**CERTIFICATE OF APPROPRIATENESS**

**Property:** 1314 Tulane Street, Lot 24. Tract 23, Block 174, Houston Heights Neighborhood Subdivision. The property includes a historic 1,238 square foot, one-story wood single-family residence and detached garage situated on a 6,600 square foot (50' x 132') interior lot.

**Proposal:** Alteration – Addition

**FLOOR PLAN – OPTION 1 (NO RAMP, SIDE STAIRS TO BE REDUCED IN WIDTH)**

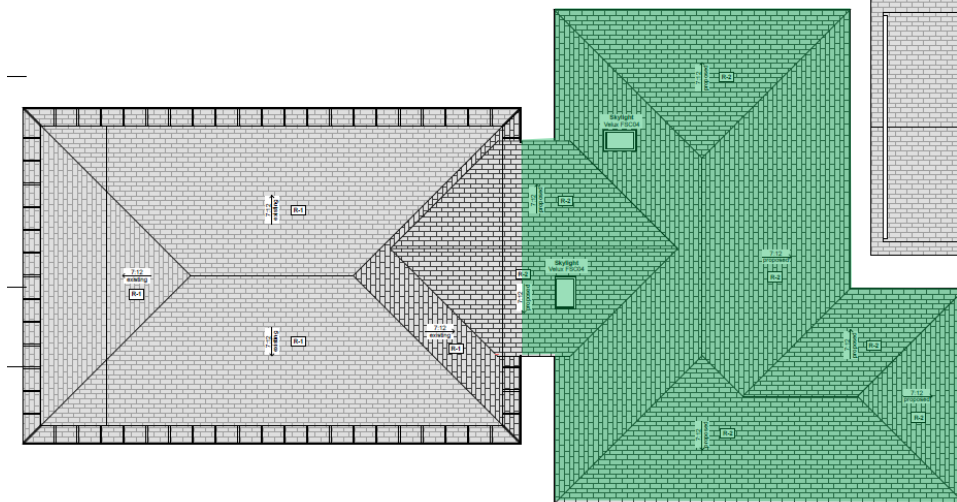
- o Side porch design will include steps (reduce in width from drawing configuration) and space for an ADA access ramp (see pg. 21-22 for options. Finalize with staff).

**Recommendation: Approval with conditions: Side porch steps to be reduced in size and not span full width of side porch. Finalize side porch/ramp design with staff.**
